## Consideration of Comments

**Project Name:** 2016-04 Modifications to PRC-025-1 | PRC-025-2  
**Comment Period Start Date:** 7/25/2017  
**Comment Period End Date:** 9/8/2017

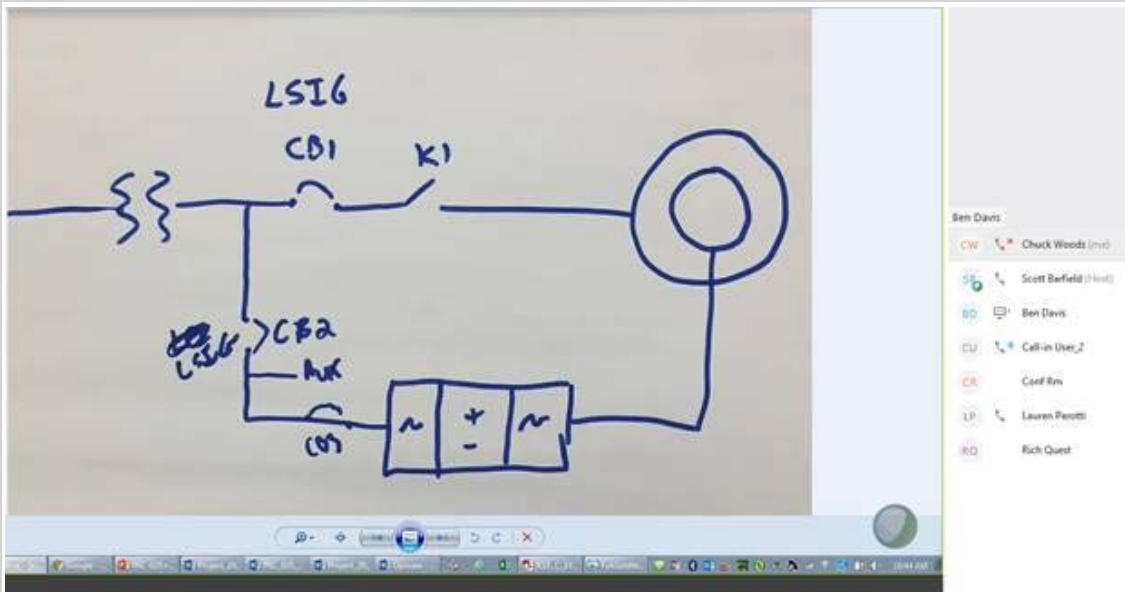
3. Request that the PRC-025 standards drafting team consider defining a NERC Dispersed Power Producing Resource Collector System such as:

**Collector System:** Radial facilities used to aggregate dispersed power producing resources designed primarily to deliver such aggregate capacity to a common point of connection at a voltage of 100 kV or above.

Figure I4-2 depicts a dispersed generation site and substation design with unknown collector system configuration.

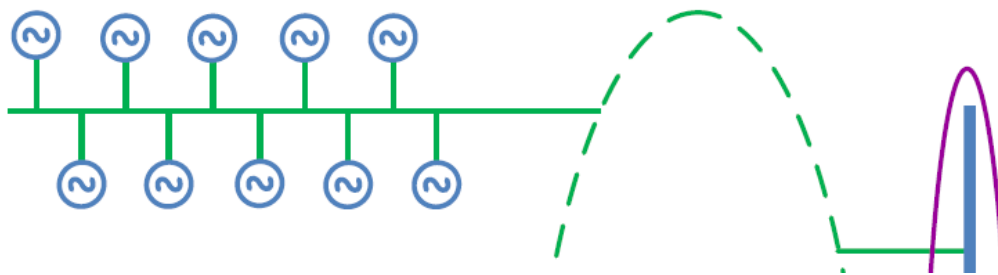
Typical dispersed generation site and substation design (single transformation of voltage level) with a gross aggregate nameplate rating of 80 MVA (Individual Generator Unit Rating: 2 MVA). By application of Inclusion I4 the dispersed power producing resources and the Elements from the point of aggregation to the common point connection are BES Elements.

Green indicates the portions of the Collector System that are not included in the BES.  
Blue identifies the dispersed power producing resources and BES Elements between the point where those resources aggregate to greater than 75 MVA to a common point of connection at a voltage of 100 kV or above.
